Re: Geologic Hazard Additional Borings
Springs at Waterview East (Trails at Aspen Ridge)
South Powers and Bradley Road
Colorado Springs, Colorado

COLA, LLC
Geologic Hazard Additional Borings
Springs at Waterview East (Trails at Aspen Ridge)
South Powers Boulevard and Bradley Road
El Paso County, Colorado

**Subject: Trails at Aspen Ridge PUDSP191 (previously reviewed as Springs East at Waterview SP-17-010)
El Paso County, CO; CGS Unique No. EP-18-0011 5**

**Subject: Trails at Aspen Ridge PUDSP191 (previously reviewed as Springs East at Waterview SP-17-010)
El Paso County, CO; CGS Unique No. EP-18-0011 4**

**SITE PLAN/TEST BORING LOCATION MAP
SPRINGS AT WATERVIEW EAST
S POWERS BOULEVARD AND BRADLEY ROAD
EL PASO COUNTY, CO.
FOR: COLA, LLC**

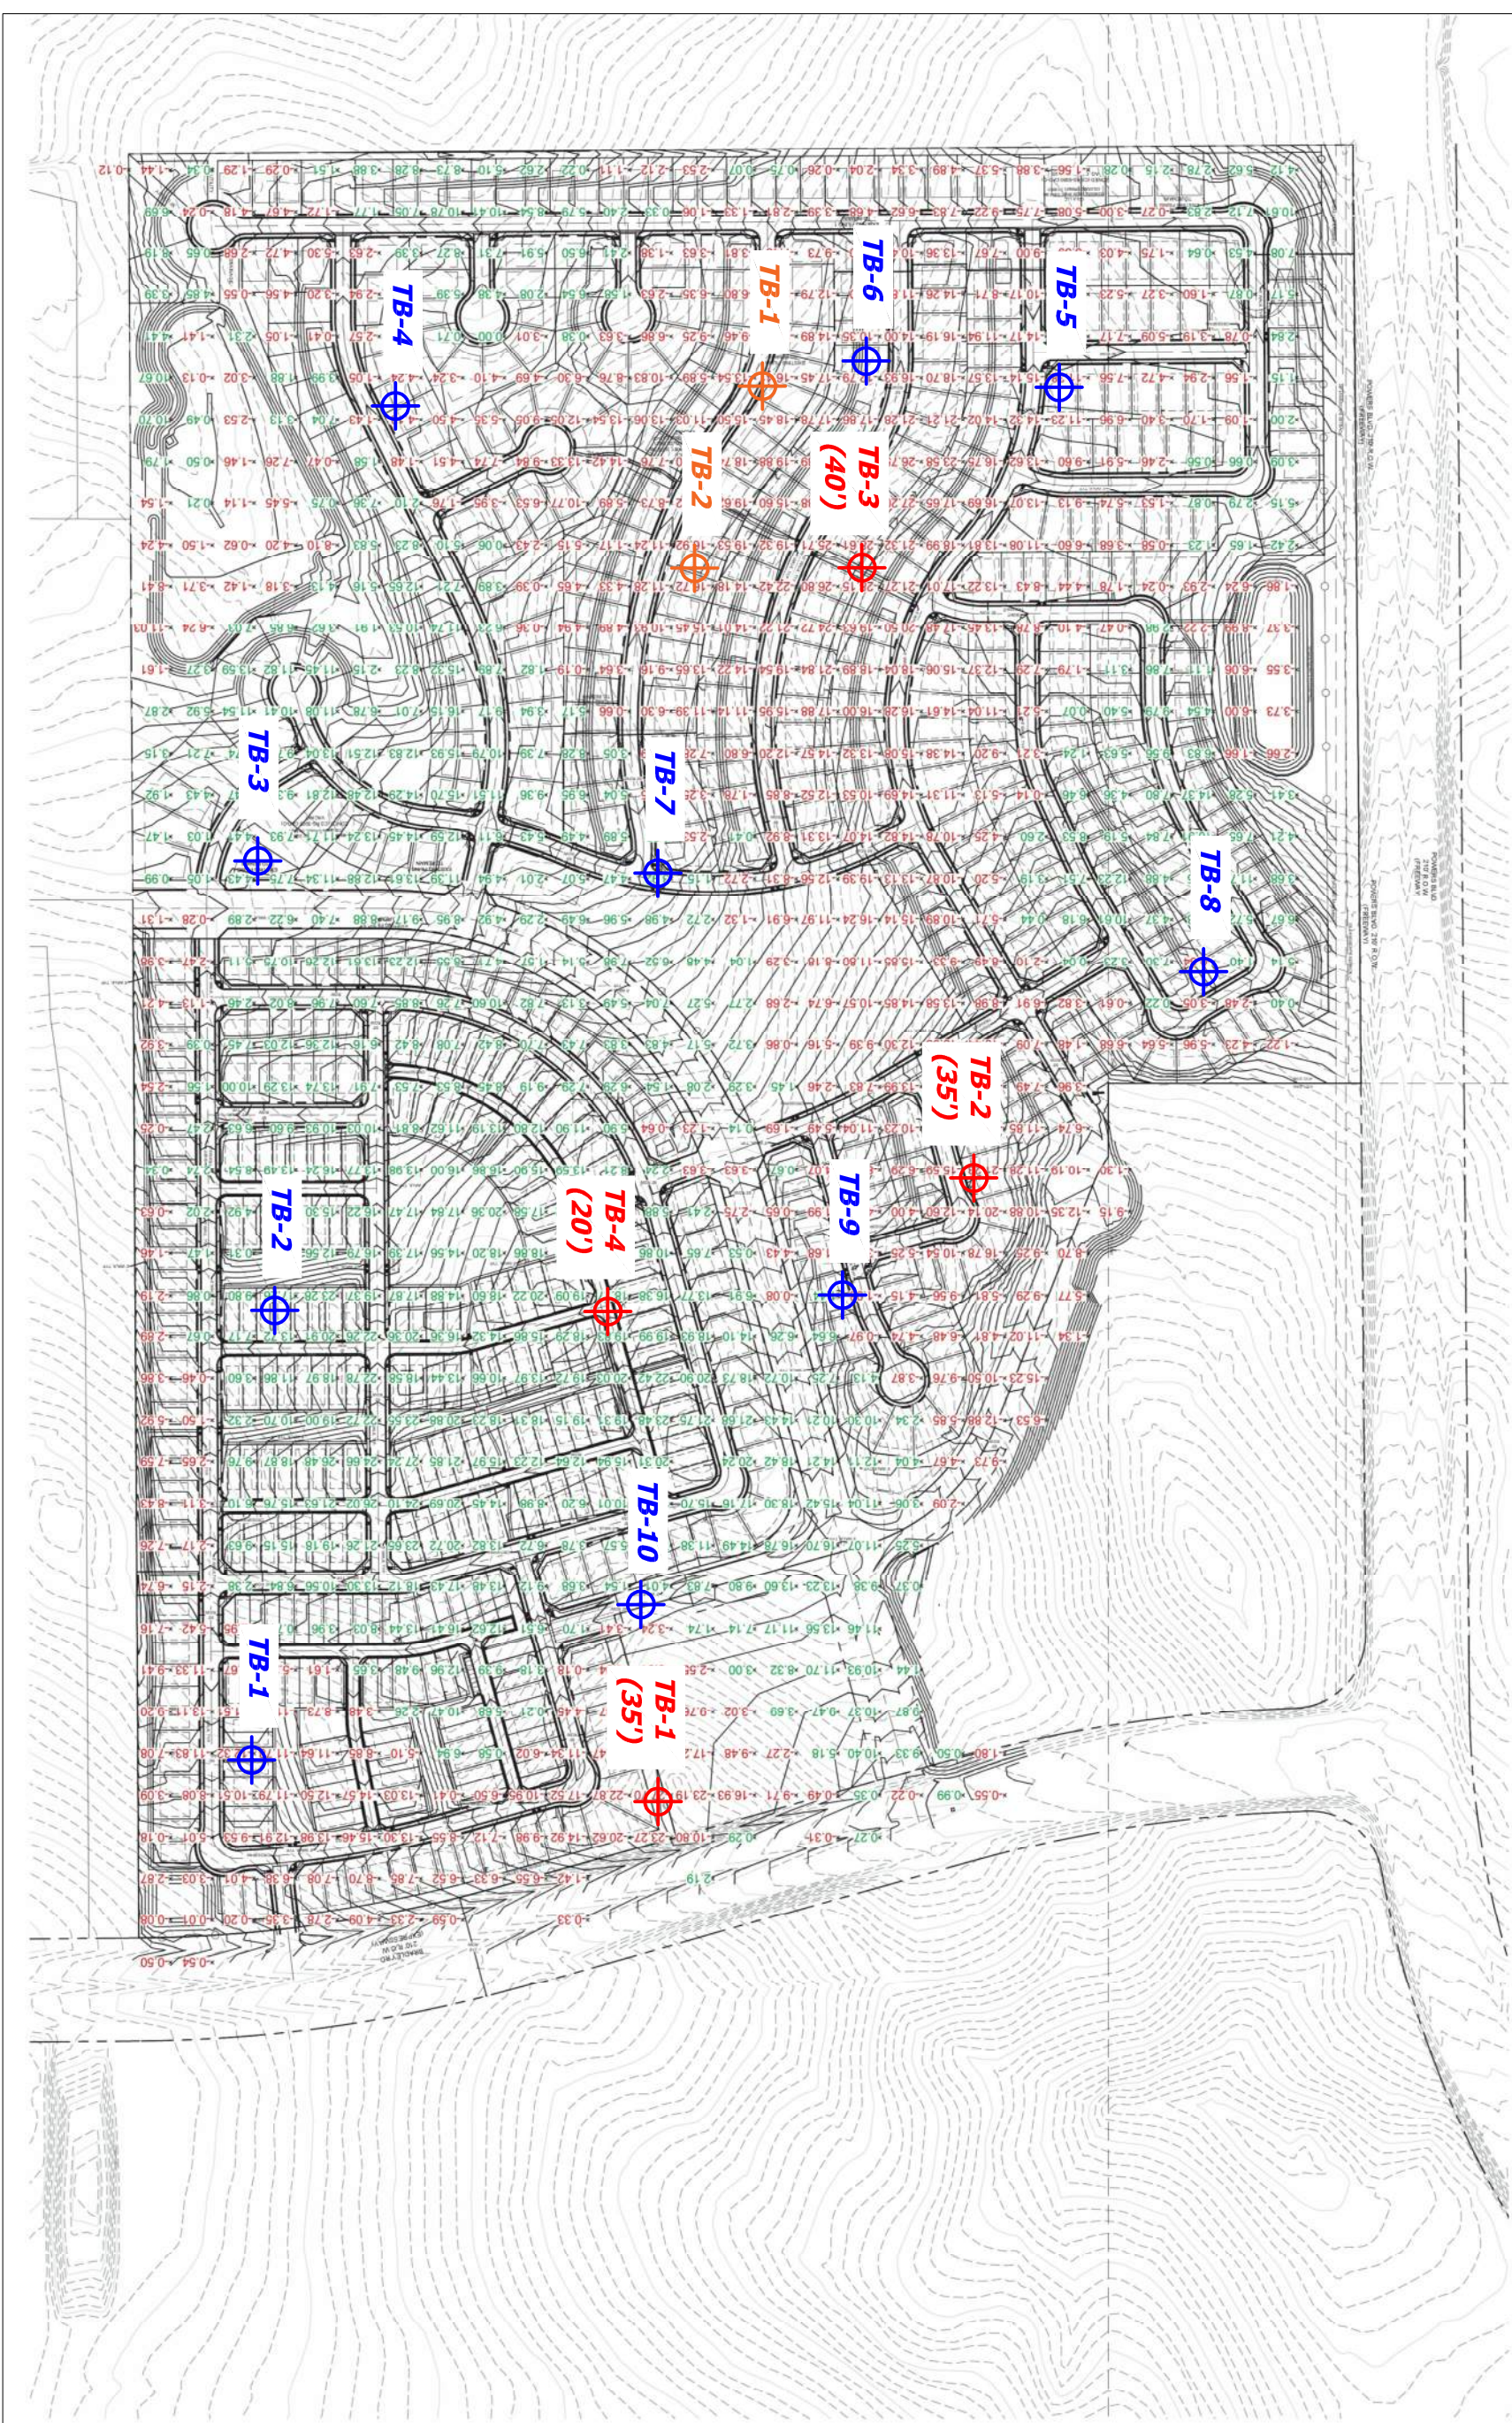
Provide memo stating findings
in report are still valid or what
has changed since report is 7
years old.

CGS previously discussed concerns about insufficient subsurface information in the northeastern and southwestern areas of the site, where significant cuts are planned. **The additional borings described by Entech in their 4/10/2019 addendum are not located within the areas of concern.**

Additional investigation, sampling, testing and analysis are needed in proposed areas of cuts exceeding about 8 feet, based on the project grading plans, to characterize subsurface conditions, determine depth and extent of overexcavation, if overexcavation is planned to reduce the use of drilled pier foundations, and to determine basement feasibility where Entech's borings did not extend to sufficient depth below planned basement floor and foundation bearing depths.

CGS recommended additional investigation on the site in areas where significant cuts are proposed. Entech drilled four additional borings on August 7, 2019. Test Boring locations are shown on Figure 1. Test Boring Nos. 1 – 3 were drilled in areas of deep cuts, and Test Boring No. 4 was placed in an area of significant fill. Groundwater was not encountered during drilling or subsequent to drilling. The test borings were drilled to depths of 20 to 40 feet. Soils encountered in these borings consisted of predominantly sandy clay soils with underlying claystone and shale bedrock. The bedrock underlying the site is the Pierre Shale Formation of Cretaceous Age, which typically has a moderate to high expansion potential.

The new borings do not alter the conclusions in the previous reports. Based on the additional subsurface information, it is anticipated claystone or shale will be exposed in the majority of cuts proposed on the site. These soils have the potential for moderate to high expansion potential. Mitigation of the expansive soils will be required for the majority of the site. Specific recommendations for foundations and construction will be provided in the Subsurface Soil Investigations after additional site investigation is performed for the different phases of the development prior to construction.

TEST BORING LOCATION MAP
TRAILS AT ASPEN RIDGE-BORROW SITE
EL PASO COUNTY, CO
FOR: COLA, LLC

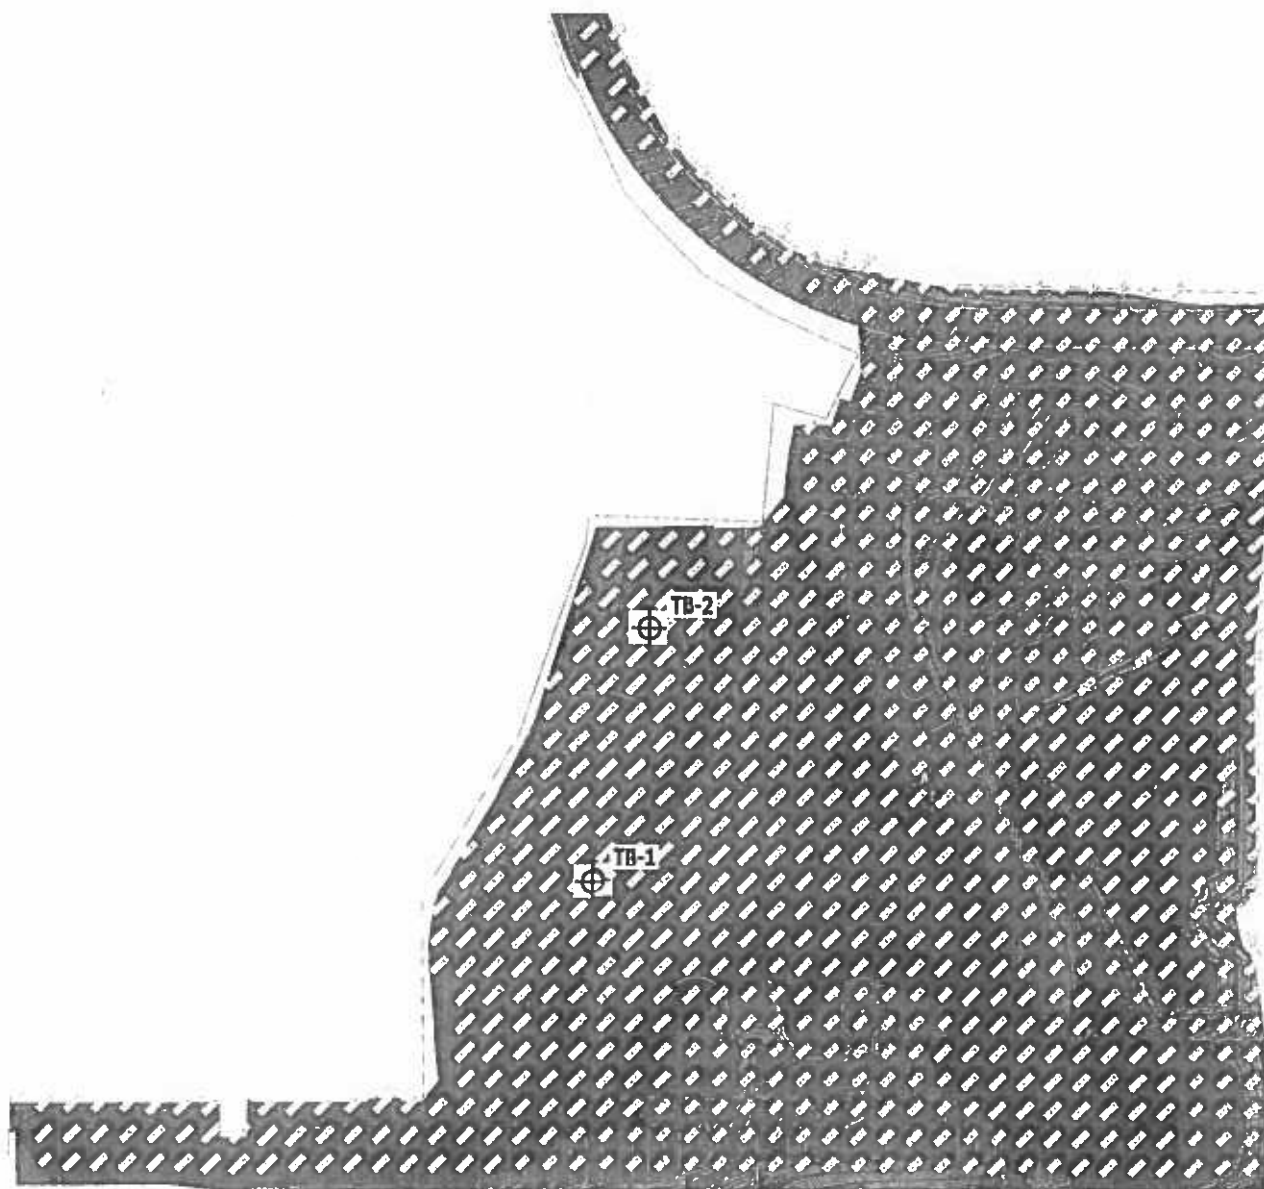
The locations of Entech's Appendix C borings are difficult to determine because of the poor quality of Figure 2, but appear to be located east of proposed Wagon Hammer Drive, outside of the currently proposed Trails at Aspen Ridge development area, within the existing Phase I (Not a Part)/Filing I Area To Remain identified on the PUD and grading plans.
